RESPONSE TO REQUEST FOR ADDITIONAL INFORMATION

APR1400 Design Certification

Docket No. 52-046

RAI No.: 398-8457

Figure 1 Core flush by hot side injection

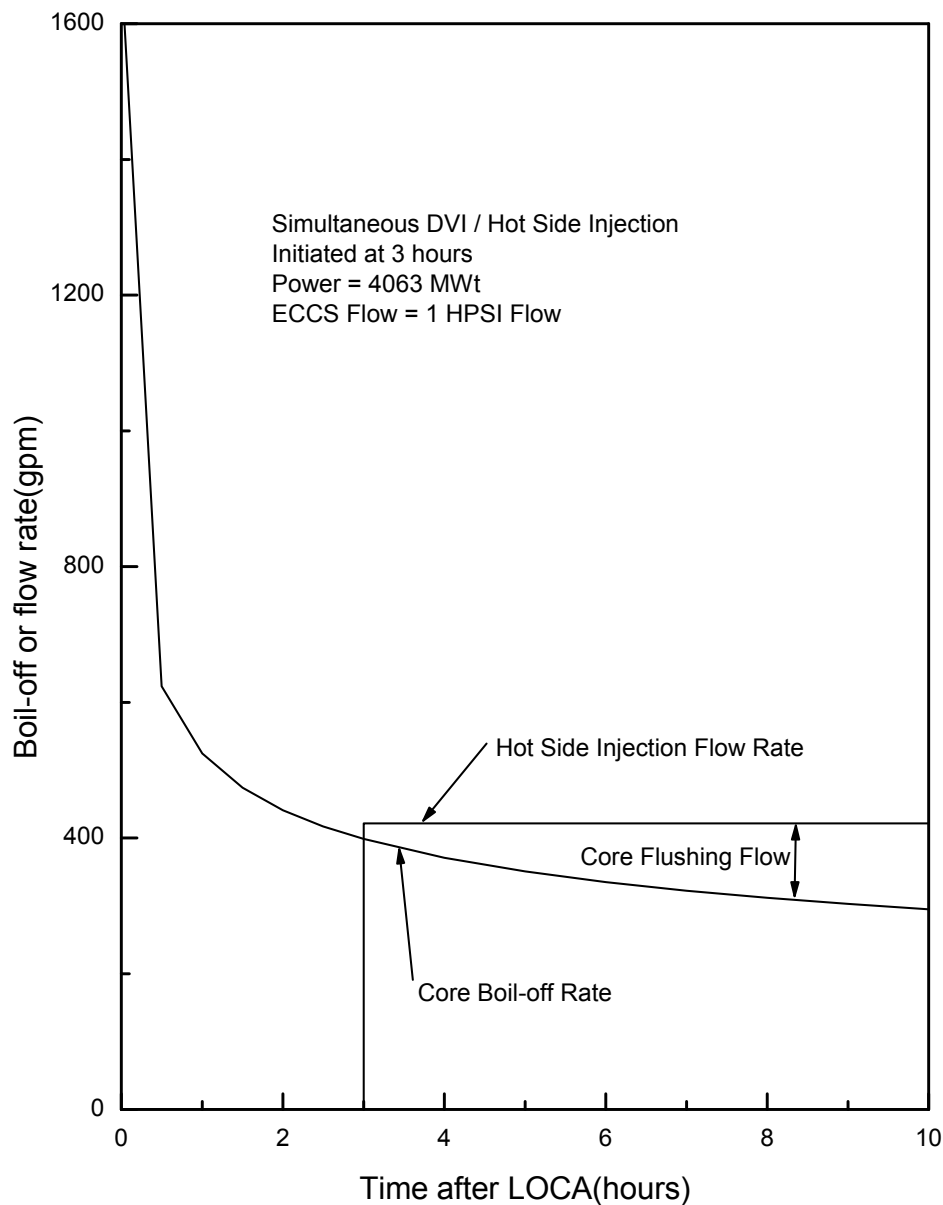
2. The analysis does not appear to account for reduced injection flow during the switchover to hot leg injection at 3 hours (Section 3.5.4). Is there a reduced flow during this transition period and how is it addressed in the calculation?

The injection flow is not considered to decrease during the switchover to hot leg injection. Instead, the injection flow is assumed conservatively. The flushing flow rate is calculated by hot side SI injection flow and core boil off rate as shown in Fig.1. Even though 2 SI pumps actuate during the switch over period, it is assumed that 4/10 of the total flow from a single SI pump enters the reactor vessel from the hot leg and all of the decay heat from the core boils off liquid. At 3 hours, core flushing flow is decreased to 23 gpm. After 3 hours, as the core boil off rate has decreased, the core flushing flow has increased. The flushing flow rate is used to compute the boric acid concentration in the core.

Figure 5. Inner Vessel Boric Acid Concentration vs. Time

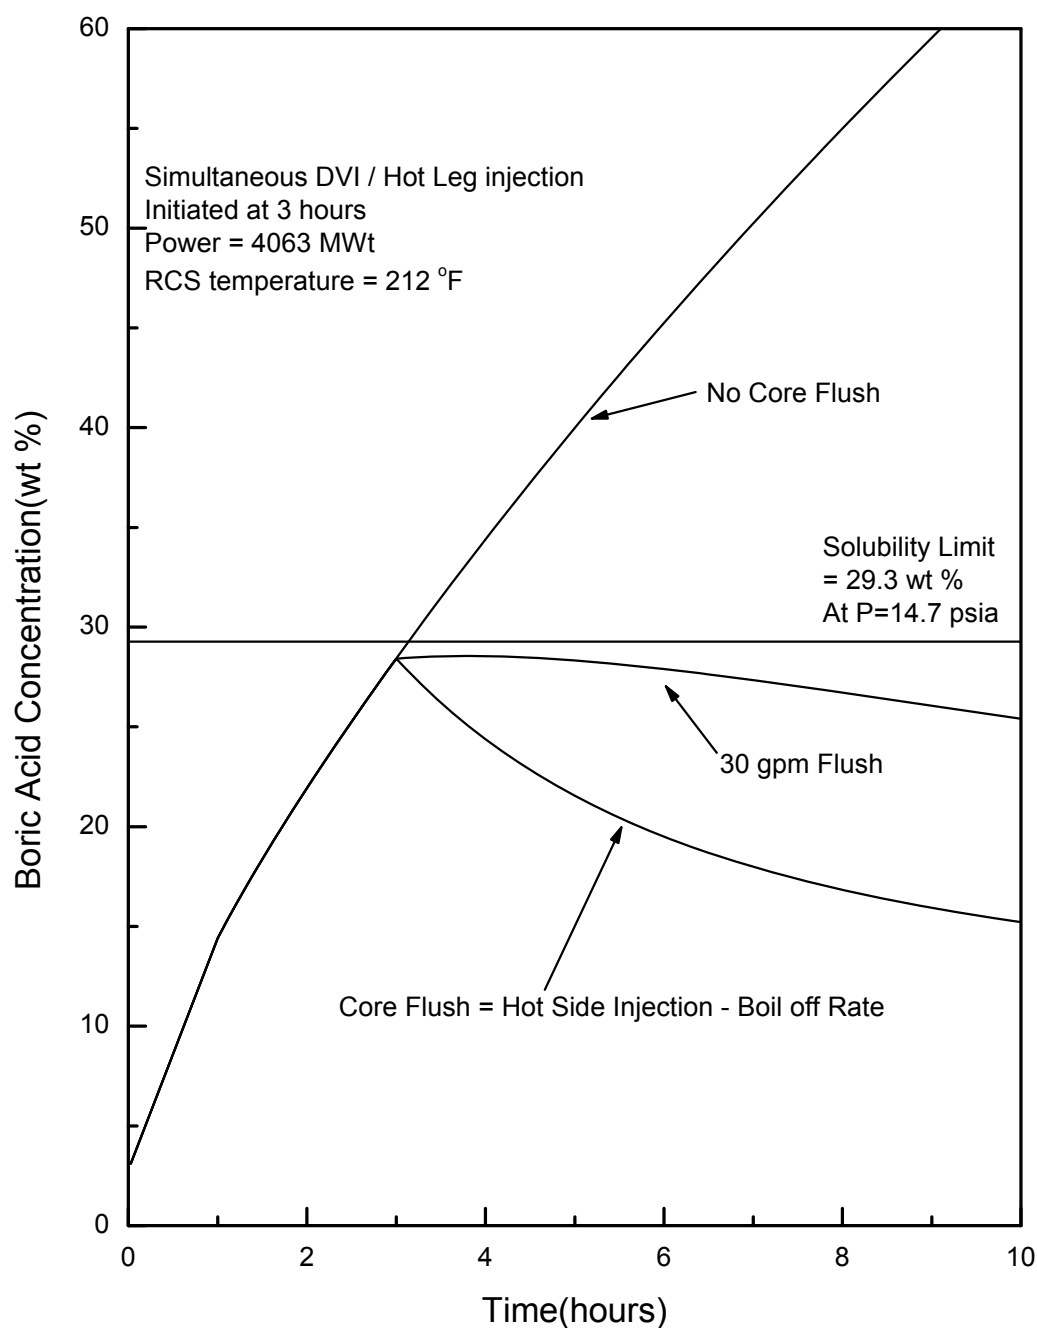
13. Figure 4-3 shows the buildup of boric acid concentration which depends on the boiloff rate and appears to be independent of break size? For smaller breaks where natural circulation is mixing the coolant, the switch to hot leg injection could possibly hinder the natural circulation by introducing cold liquid into the hot side of the natural circulation loop. How does the approach used address this possibility?

The double ended cold leg break size is the limiting break for long term boric acid accumulation in the inner vessel region, because the largest amount of coolant with high boron concentration is added to the inner vessel from SITs and SI pumps. Therefore, only the double ended cold leg break size is considered to calculate boric acid concentration by the BORON code. Thus, the boric acid concentration for the double ended cold leg break size is depicted in Figure5.

The mixing volume for computing the boric acid concentration is changed to include the additional volume from the top of the core to the top of the hot leg piping at the RV outlet nozzles. If the water level in the inner vessel is higher than the top of hot leg, boron precipitation is not a concern. Natural circulation is not considered in the BORON code because natural circulation begins when injected water refills to the top of the steam generators, in the case of smaller break sizes.

Even though the switch to hot leg injection could possibly hinder the natural circulation by cold water; boron precipitation does not occur around the top of the core. Thus natural circulation is not addressed in the BORON code.

Figure 6. RCS Pressure after Refill vs. Break Area

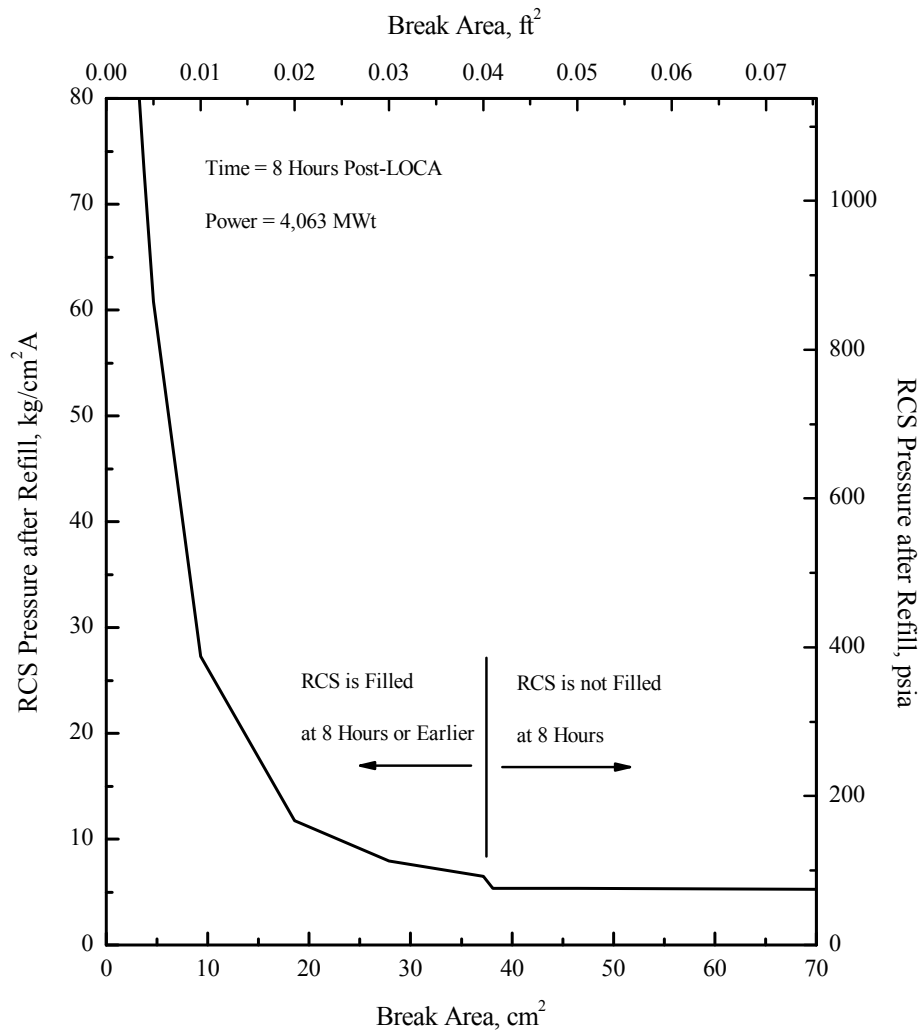
12. Figure 4-2 shows that the “Pressure after Refill” as a function of break size settles out to approximately 80 psia for breaks between 0.04 and 0.07 ft². What physical phenomenon is causing the pressure to remain constant for this wide range of break sizes?

14. In the CENPD-254 methodology, the maximum break size for the small break analysis is determined by the auxiliary feedwater capacity. There is no mention of auxiliary feedwater capacity in the technical report. How was the upper limit size determined for the small break?

The decision time at which the operator decide whether to use the large break procedure or the small break procedure in order to continue the cooldown of the RCS. This time (8hr) is determined between the earliest time at which the SDC entry conditions can be achieved, and the latest time for which auxiliary feedwater can be assured to be available.

In order for the SDC system to be used to remove heat from the RCS, there must be sufficient liquid in the hot leg from which it takes suction. If RCS is refilled before the decision point time, the break case is assured of having sufficient coolant in the RCS to use the SDC system. Thus, the decision time determines the upper limit size of small break for which the SDC system can be used. This break size is 0.04 ft^2 as is shown in Figure 6 below.
